ISSUE ALERT LETTER #14

Attached is Issue Alert Letter #14 detailing a screen problem and its fix on T21XXCS systems.

Issue Alert Letter #14

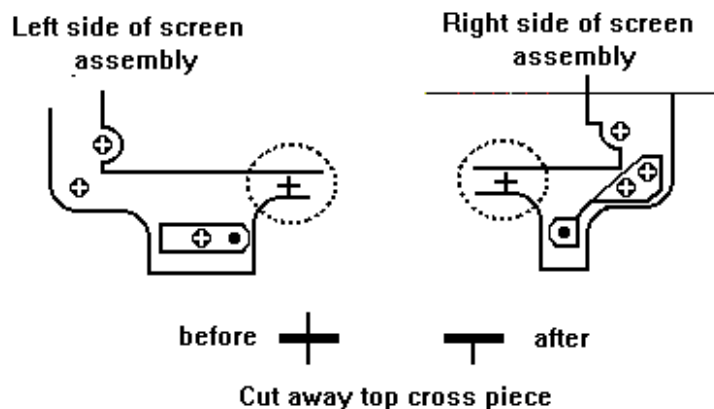
During reassembly, the screen on a T21XXCS system is often positioned too low and allowed to contact the cross-shaped posts molded into the bottom edge of the top cover. If a sufficient gap is not maintained between the edge of the screen and the post, light shock or the closing action can leave small indentations on the metal frame of the screen. These indentations may cause damage to the drivers mounted along the bottom edge beneath the frame. This can result in vertical lines being displayed or dark screen failures.

To eliminate the possibility of damage, the top cross piece of both the left and right side posts should be cut away as shown in the illustration.

This piece can be shaved down using small diagonal cutters or a knife. The piece removed may have a conductive coating, so care should be taken to prevent pieces of the cut plastic from dropping down into the system. This cut should be applied anytime a T21XXCS system is brought in for service.
